3.1**7 Hill Street Queenscliff - Alterations and Additions to Existing Semi-detached Dwelling****DEVELOPMENT ASSESSMENT REPORT**

Assessment Officer:	Sarah McNeilly Consultant Town Planner Watermark Planning
Address / Property Description:	7 Hill Street, Queenscliff
Proposed Development	Major alterations and additions to existing semi-detached dwelling including a second storey, basement car parking and an in-ground swimming pool.
Development Application No:	DA 2008/1773
Application Lodged:	23 December 2008
Plans Reference:	Drawing Numbers DA-02, DA04-DA-06 Issue A and DA-03, DA-07-DA-15 all dated 20/8/08 and drawn by Tom Potter Architects.
Amended Plans:	NO
Applicant:	Scott Manuel
Owner:	Scott Manuel and Linda Manuel
Locality:	H1 – Freshwater Beach
Category:	Category 1 - Housing
Variations to Controls (Cl.20/Cl.18(3)):	Landscaped area, height, side setback
Referred to ADP:	<i>Yes – Referred at the discretion of The Managers of Planning and Development Services for consideration under Cl 4(a) of ADP Charter</i>
Referred to WDAP:	NO

PROPOSED ADDITIONS AND ALTERATIONS 7 HILL STREET QUEENSCLIFF		NOTIFICATION PLANS ELEVATIONS	
DRAWN TJP	APPROVED	PROJECT NO. 8008	SCALE NTS
DATE 13/12/08		DRAWING NO. DA000

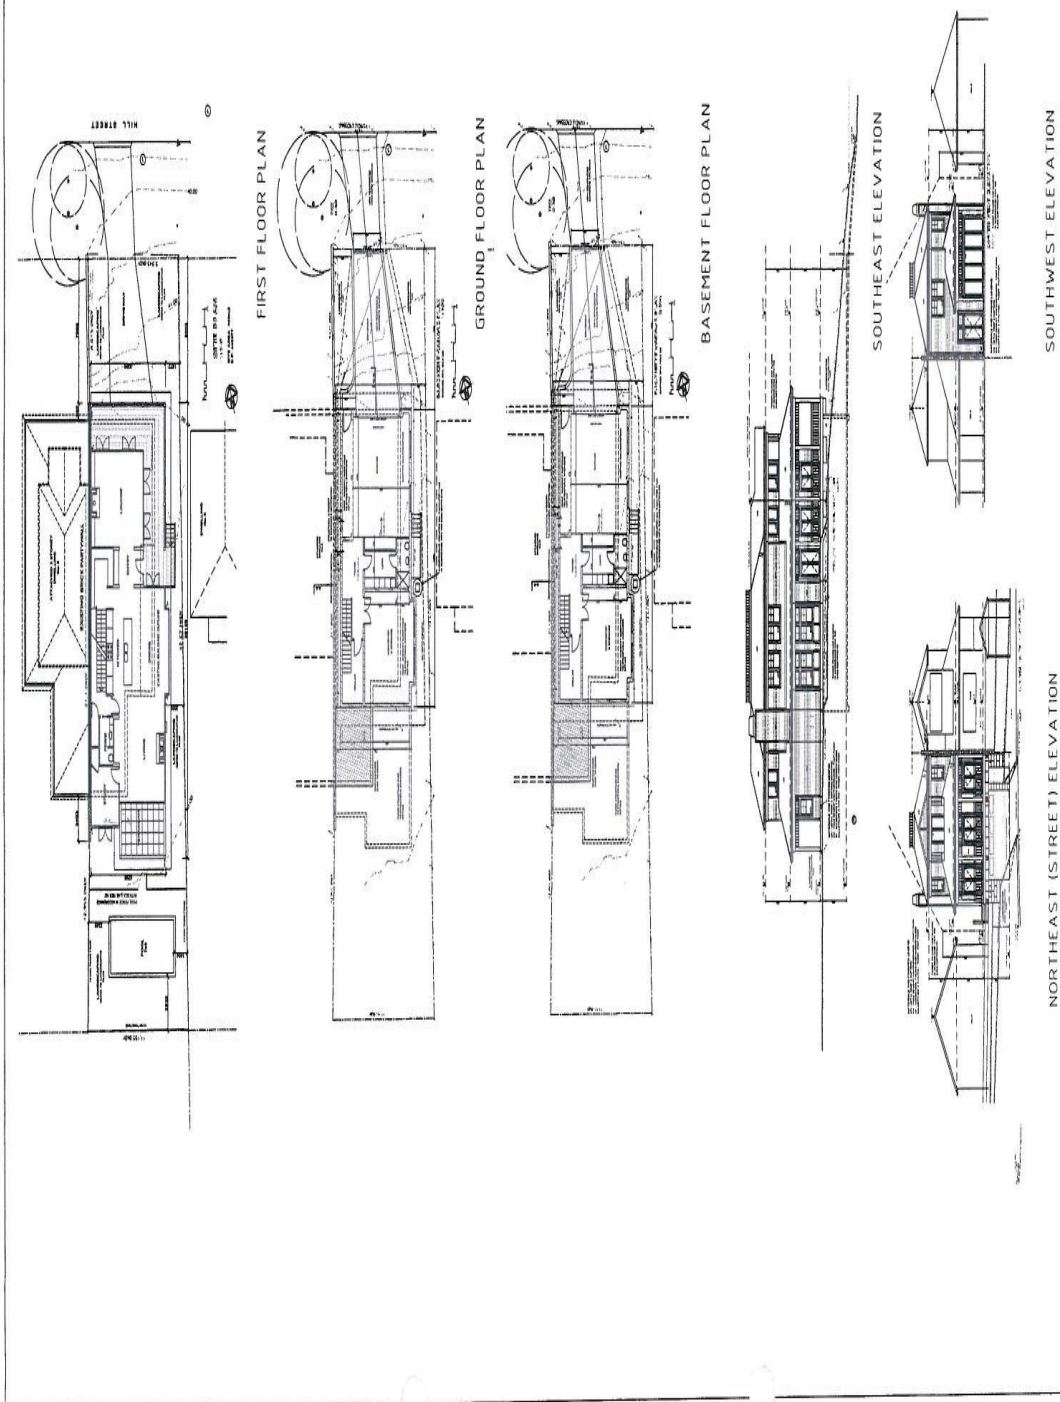
Comment: The height appears to reach a maximum of 9.2 metres to the roof detail at the highest point of the dwelling. No RLs are provided at this point, so these figures have been scaled. This is non-compliant and this area needs to be reduced to be consistent with the neighbouring half of the semi-detached dwellings. This is grounds for refusal.

7.2 metres to ceiling	7.2 metres	Yes	
Front Setback	6.5 metres	8 metres 7.35 metres to eave	Yes *While this numerically complies, it is not considered the best design to bring the front façade of the semi-detached dwelling forward of its adjoining neighbour. One side having a roofed veranda forward of the other side will not allow for appropriate continuity and balance between the two dwellings.	
Rear Setback	6 metres	9.6 metres – dwelling 8.1 metres – verandah 1.5 metres- pool	Yes Yes Yes- pool is permitted within rear setback if it does not exceed 50% of setback area. The proposed pool takes up approximately 32% of the 6 metre rear setback area.	
Side boundary envelope	45° – 5 metres	45° – 5metres -with the exception of chimney	Yes	
Side setback	0.9 metres	0.6m stair access on ground floor	No	33%

Response: The highest point of the roof scales at 9.2 metres on the plans provided to Council. No RL is provided for this component of the dwelling. Being a semi-detached dwelling, it is considered particularly crucial to have the two dwellings consistent, particularly with regard to height. No justification is seen to allow this variation. It is believed a revised design could alleviate this issue.

Comment: The height will be inconsistent. Minimal redesign could resolve this issue. It is an unnecessary non-compliance with no specific reasoning to support the departure from the control.
